LiDAR Quality Assessment Report

UT_FEMAHQ_B1_2018

Project: UT_FEMAHQ_B1_2018

Contractor: Quantum Spatial, Inc.

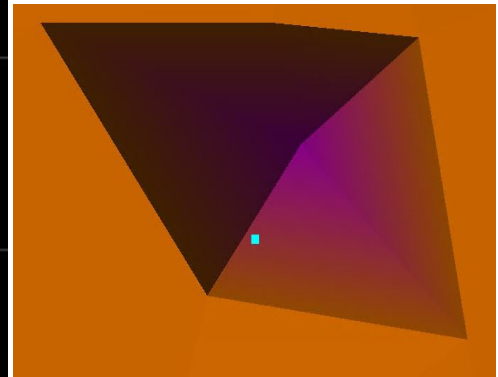
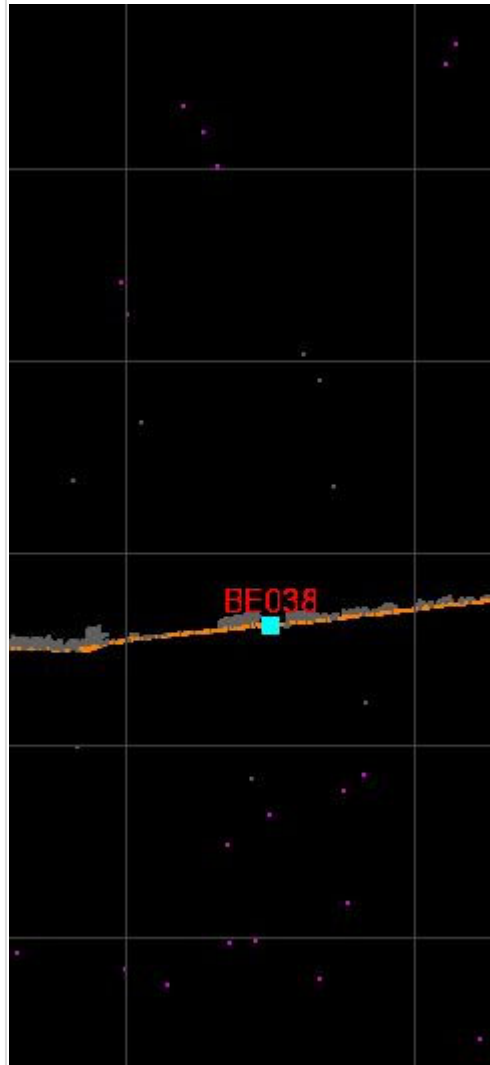
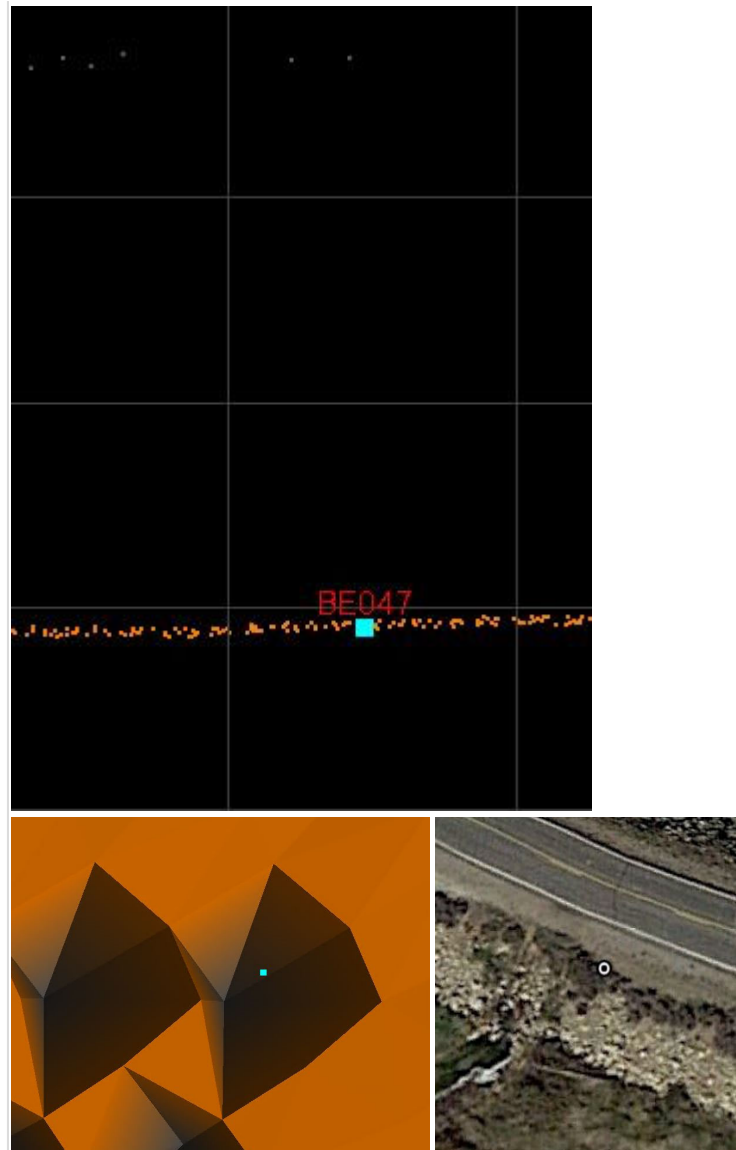
- BE38 and BE47 have a DeltaZ over 6.

BE38 -1246817.102 2020561.545 2213.710 2190.125 Control 23.585

BE47 -1212071.899 2009534.697 1788.150 1794.571 Control -6.421

If BE47 ($zDiff = -6.421$) is removed, the VA fails ($RMSEz = 218.07$ cm).

If BE38 ($zDiff = 35.828$) is removed, the VA fails ($RMSEz = 58.0$ cm).

If both BE38 and BE47 are removed, the VA passes ($RMSEz = 3.3$ cm).

****Reported NVA VA for the LPC is significantly different from NGTOC
Tested NVA VA for the LPC. Please provide and explain/elaborate your
BE47 and BE38 $zDiff$ values.**

Corrected 5/15/2019 Points

removed from analysis by contractor

Corrected 5/15/2019 Points

removed from analysis by contractor

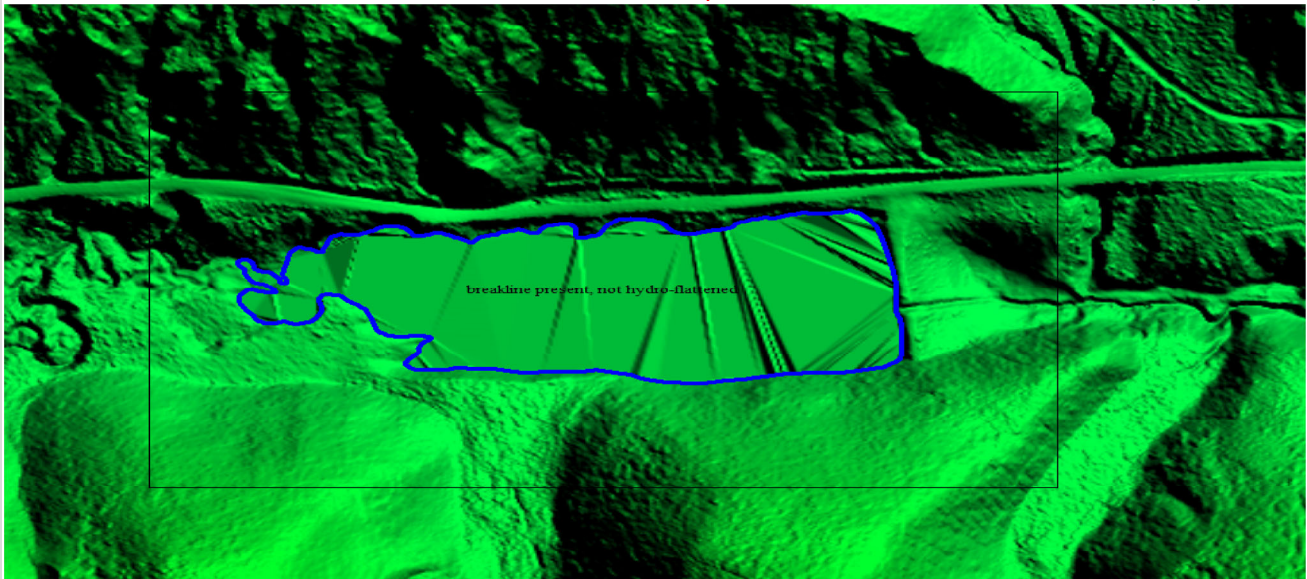
There is one lake where there is a breakline, but the lake is not hydro-flattened in the DEM. Corrected 2/20/19

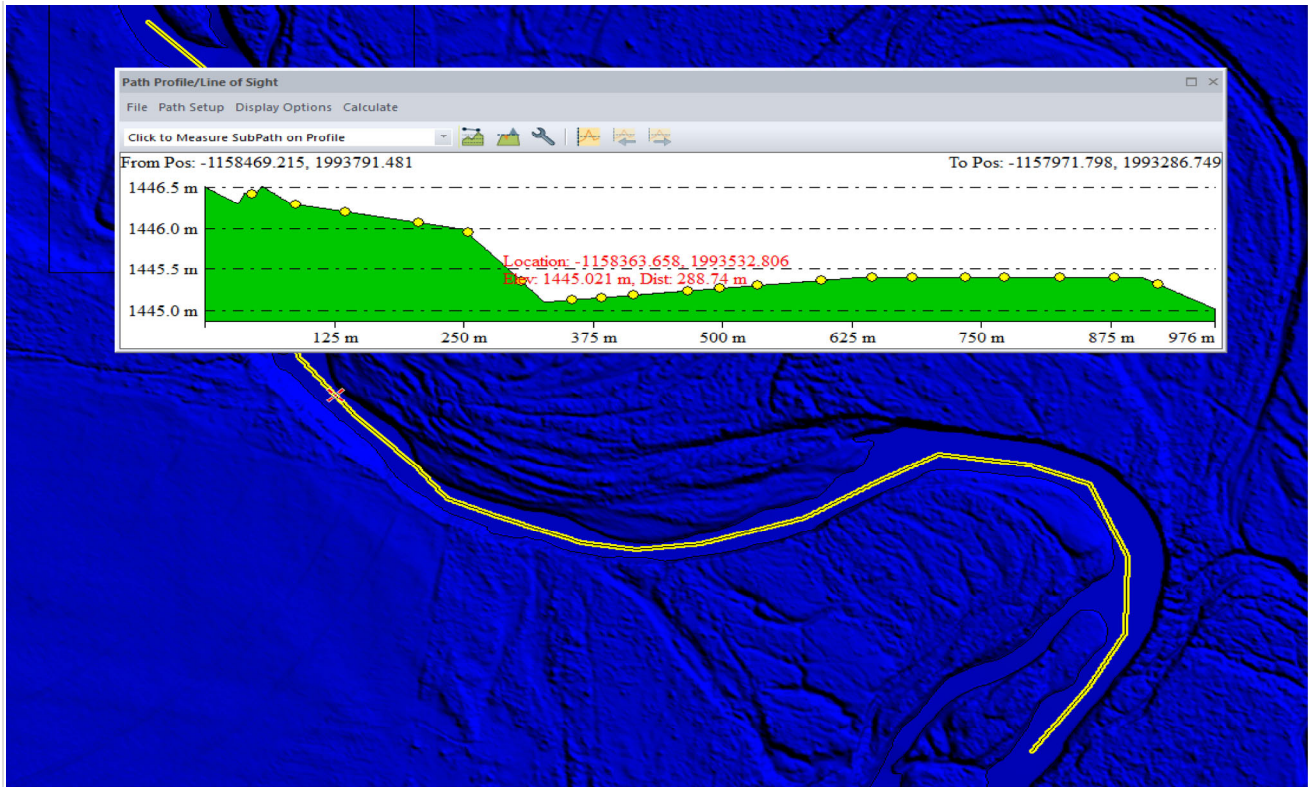
There are two river_geometry_errors. Corrected 2/20/19
